INSTRUCTIONAL BULLETIN NO. 17-09

Regarding Revised Standard Drawings

Effective February 9th, 2018 letting (November 29th, 2017 Turn-in), the following Standard Drawings have been revised. Also, Section 5, Index of Standard Drawings, of the Roadway Design Guidelines has been revised to incorporate these changes.

29-JUN-2017 14:27 \\AG03DCWF00008.net.ads.state.in.us\13SHARED\StandDraw\Working Folder For Eugene\backup dlpak on j96208\WORKSTD\2017 std dwg\TPBR1-20170316.dgn

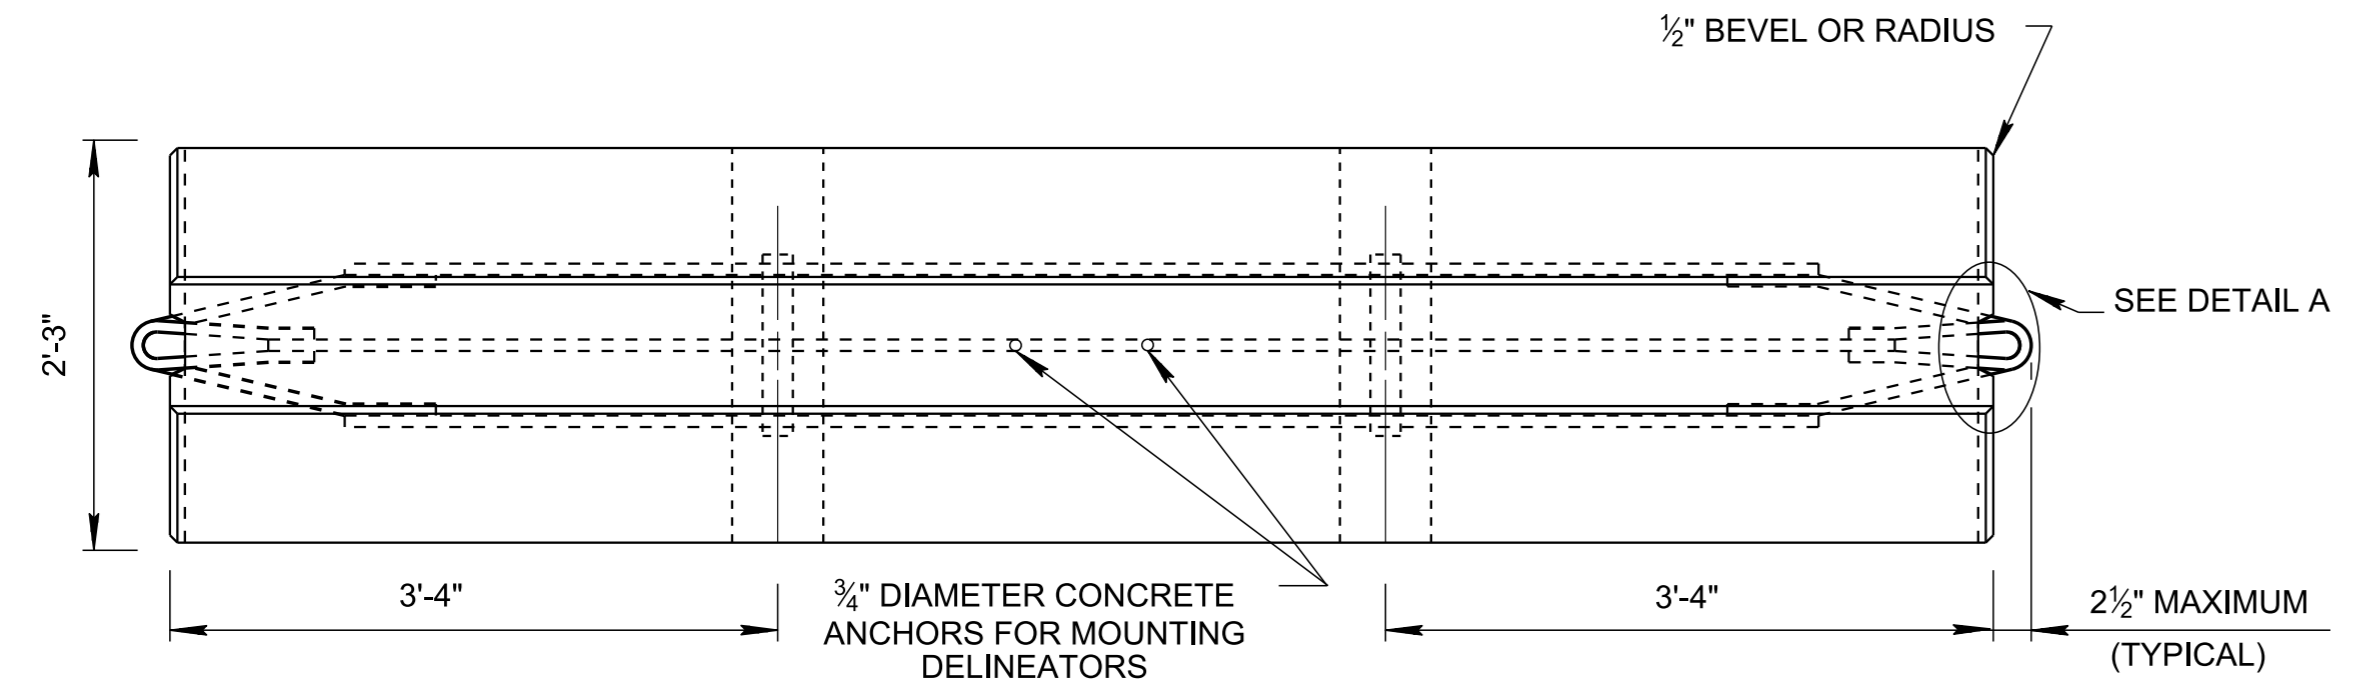
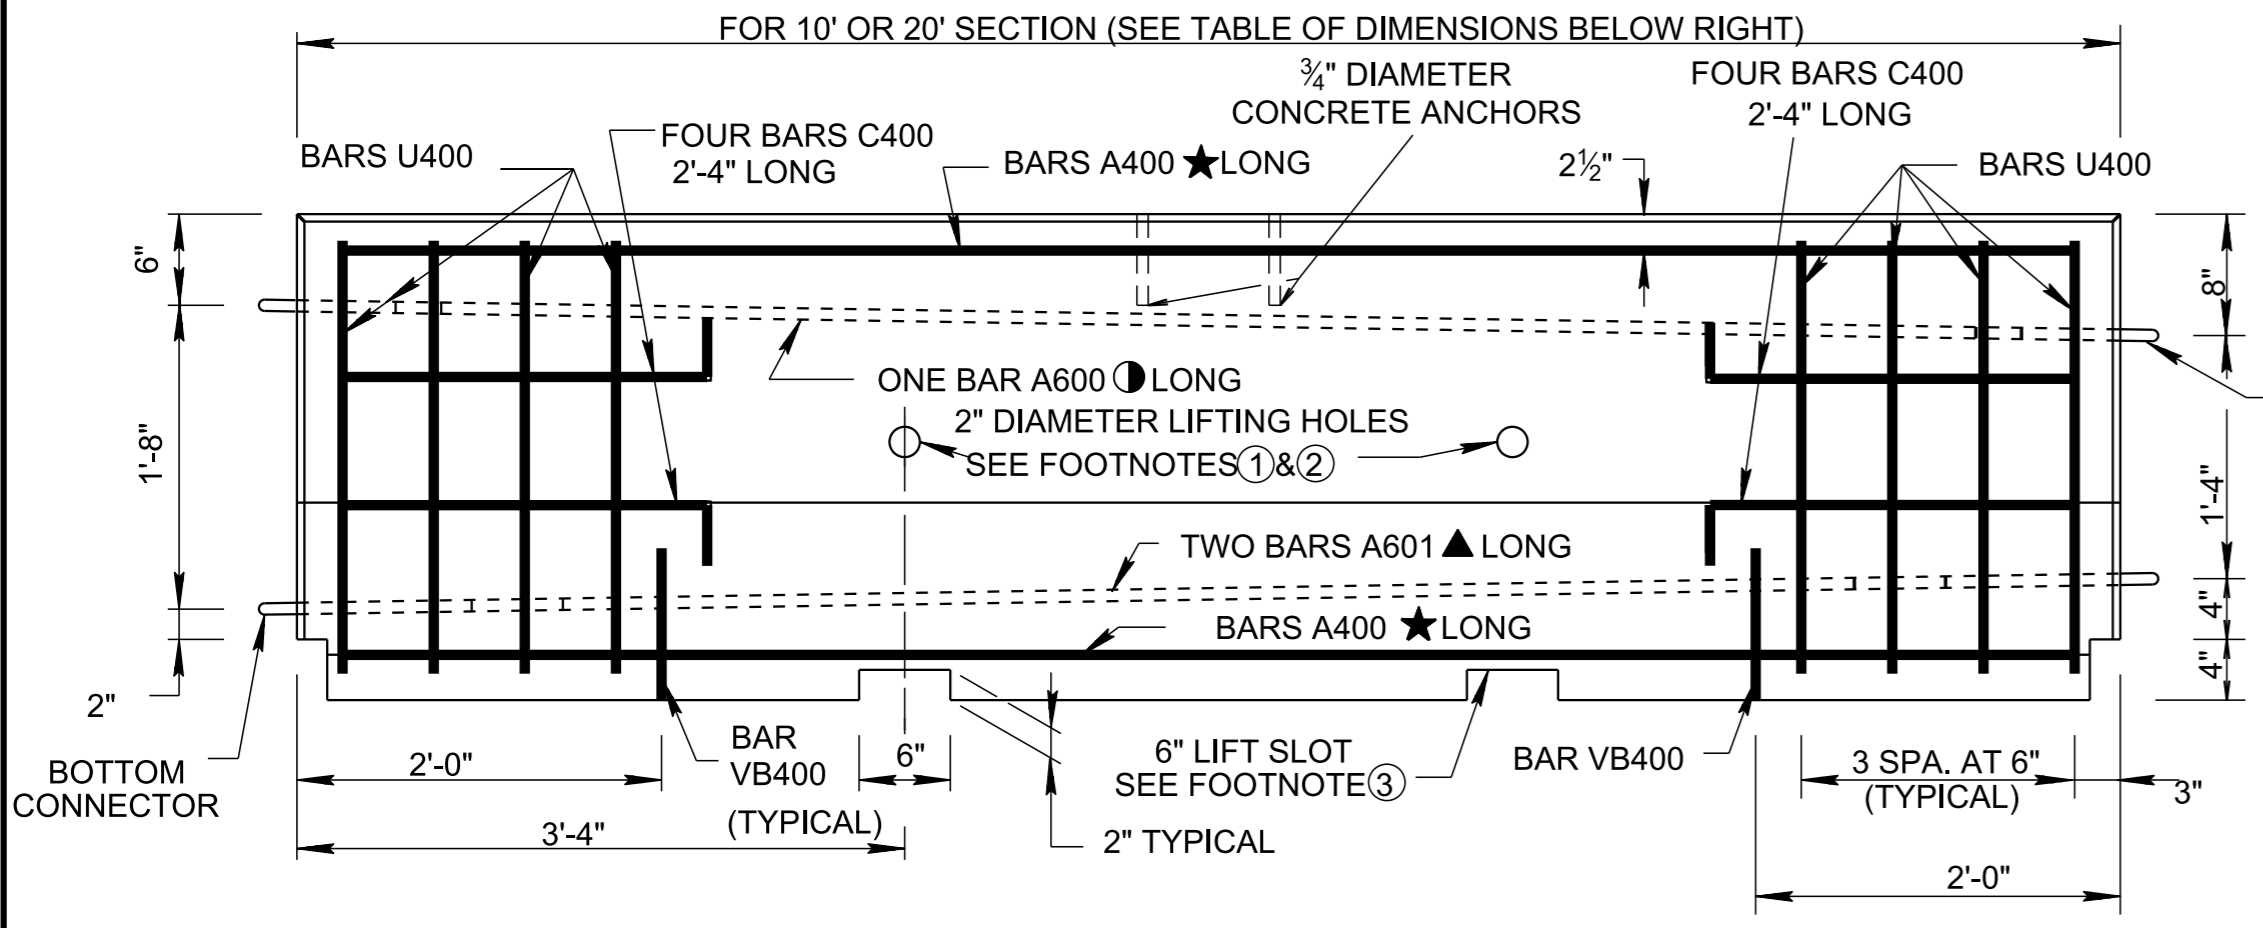
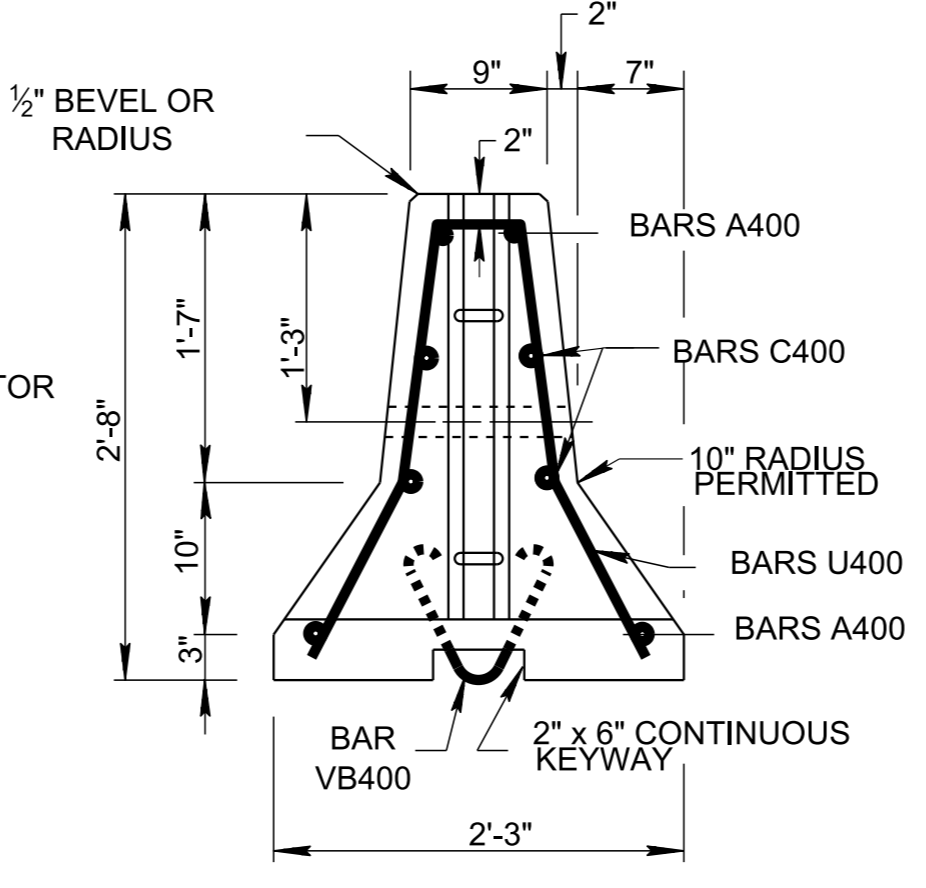
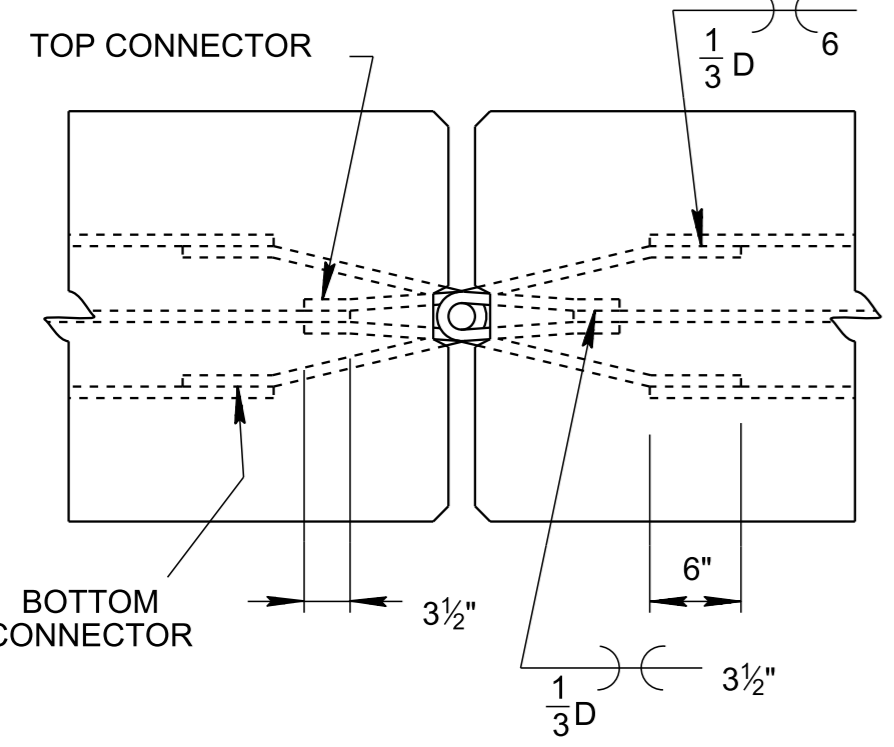
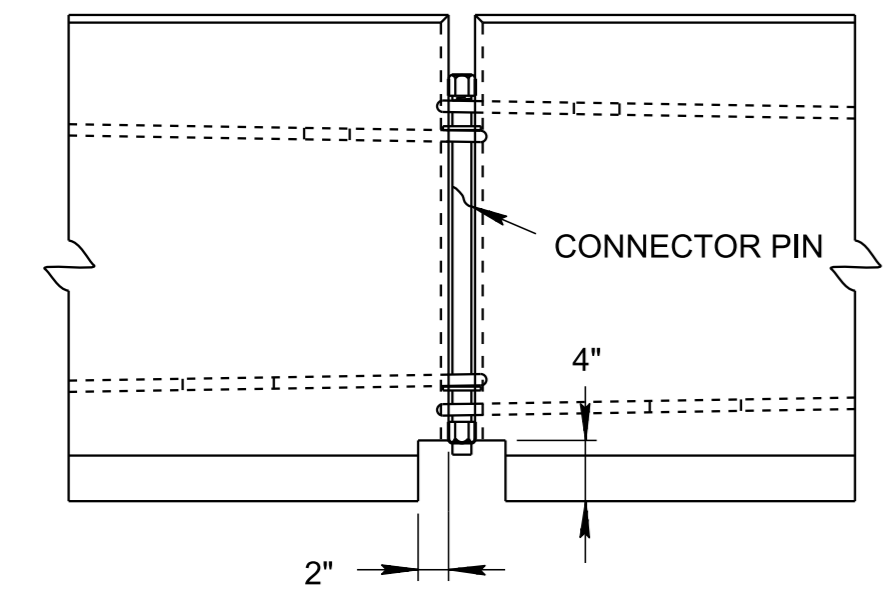
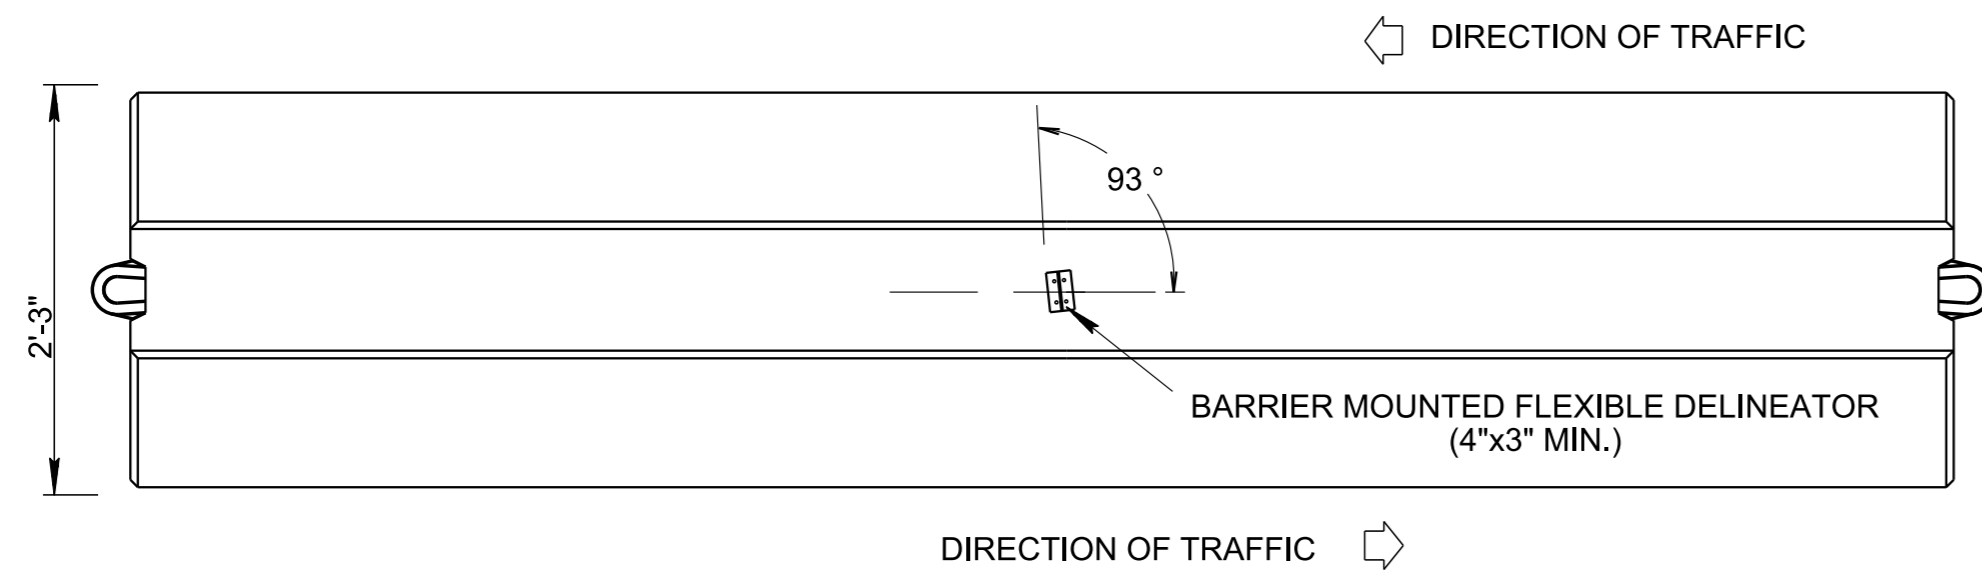
REV. 3-16-17: ADDED GENERAL NOTES ①, ②, ③ AND ITEM NUMBERS. REVISED BILL OF STEEL. REPLACED VERTICAL PANELS WITH DELINEATORS.
